ECE/TRANS/WP.15/AC.1/2006/4 30 December 2005

Joint Meeting of the RID Safety Committee and the Working Party on the Transport of Dangerous Goods (Bern, 20-24 March 2006)

#### **Paragraph 6.10.3.7 a)**

Executive Summary: Discussion about an alternative design of the suction boom on

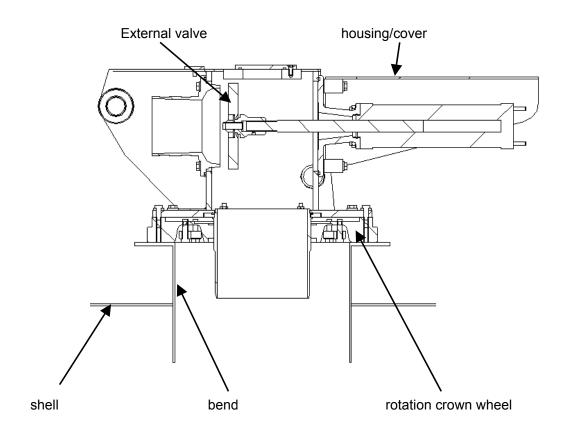
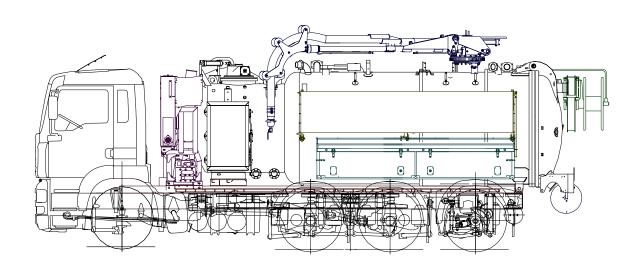
a) The boom is fitted with an internal or external stop-valve fixed directly to the shell, or directly to a bend that is welded to the shell; A rotation crown wheel can be fitted between the shell or the bend and the external stop valve, if this rotation crown wheel is located in the protected area and the stop-valve control device is protected with a housing/cover against the danger of being wrenched off by external stresses.

- The proposed modification of the text in 6.10.3.7 a) is an alternative design of a suction boom as used for many years in Switzerland and in other countries.
- The life cycle of the external valve is more than 3 years and much higher than the one of a standard slide valve.
